THE CITY OF SAN DIEGO
MAYOR JERRY SANDERS

M E M O R A N D U M

SUBJECT: Notice of Change in Size of Detectable Tactile Warning (Truncated Domes) on Curb Ramps

DRAWING NUMBER SDG-130

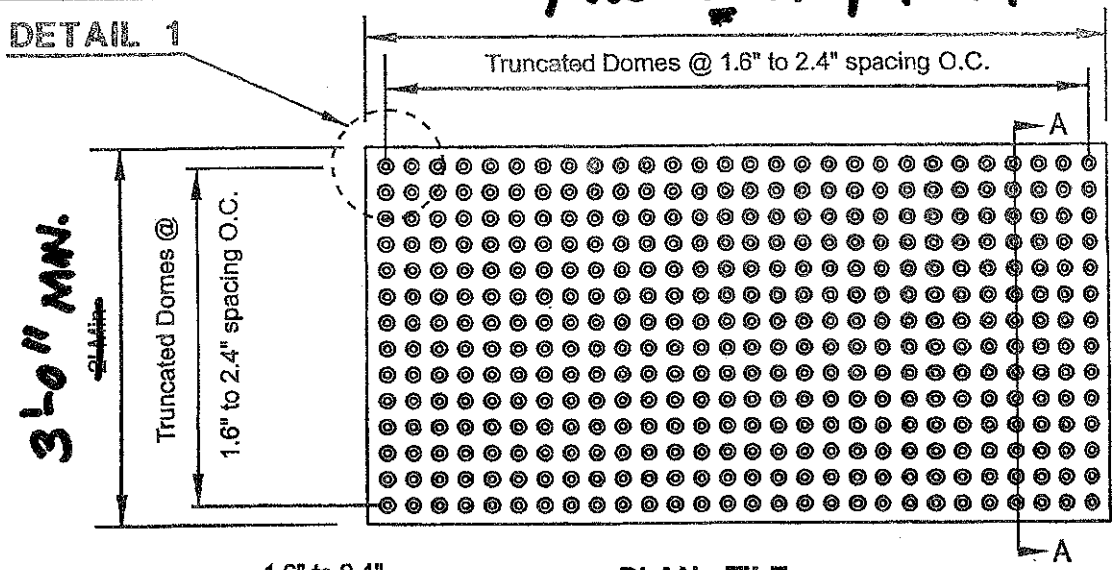
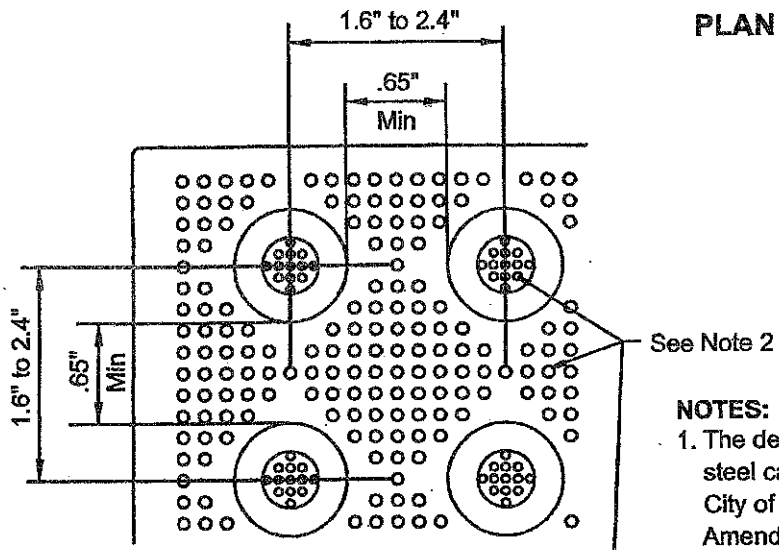
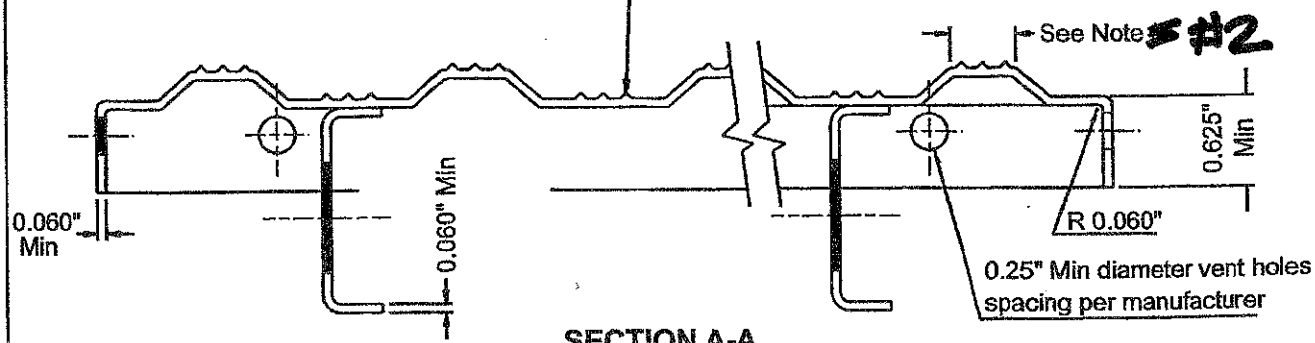
1. **Size:** The detectable warning surface shall extend 36 inches minimum in the direction of travel for the full width of the curb (See attached). This dimension shall replace the 24 inches deep and 48 inches wide dimension indicated in standard drawing number SDG-130 of the City of San Diego Standard Drawings, Document No. AEC1231063, dated December 31, 2006.

FULL WIDTH OF RAMP
